Docket No. 37024

REPORT OF NATURAL GAS SAFETY

INSPECTION NO: JB25-005

OPERATOR: AGL - Valdosta

Ray City Station

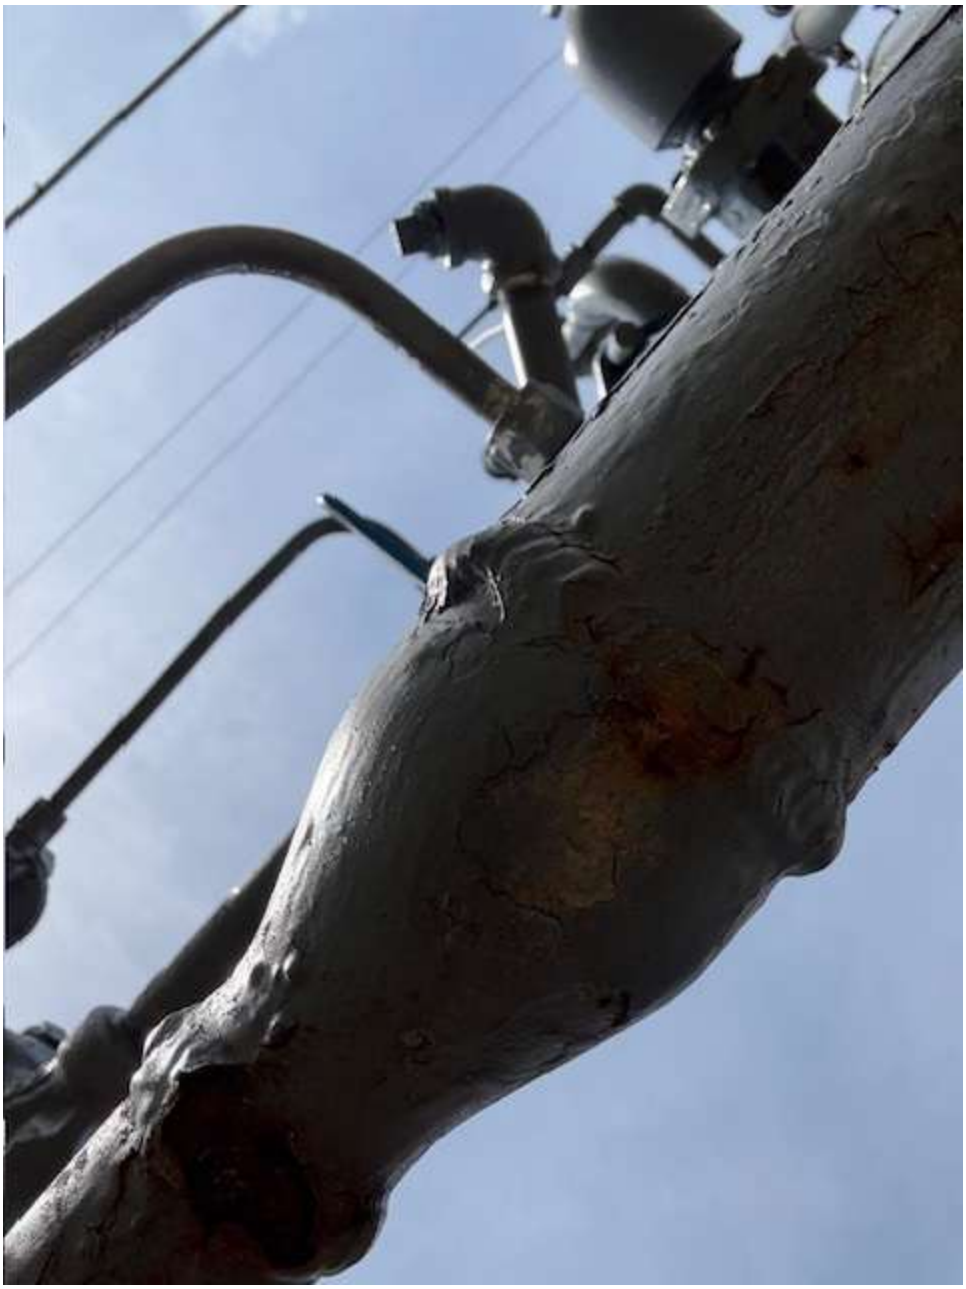
During field evaluations Staff noted multiple instances where the Operators' facilities were found to have deteriorated coating, atmospheric corrosion, exposures from loss of cover, or other unusual operating and maintenance conditions that were not being addressed. (See attached photos)

PROBABLE VIOLATION: AGLC personnel have failed to identify and report factors or conditions that could affect the safe operation of the company's facilities so that they can be remediated in a timely manner.
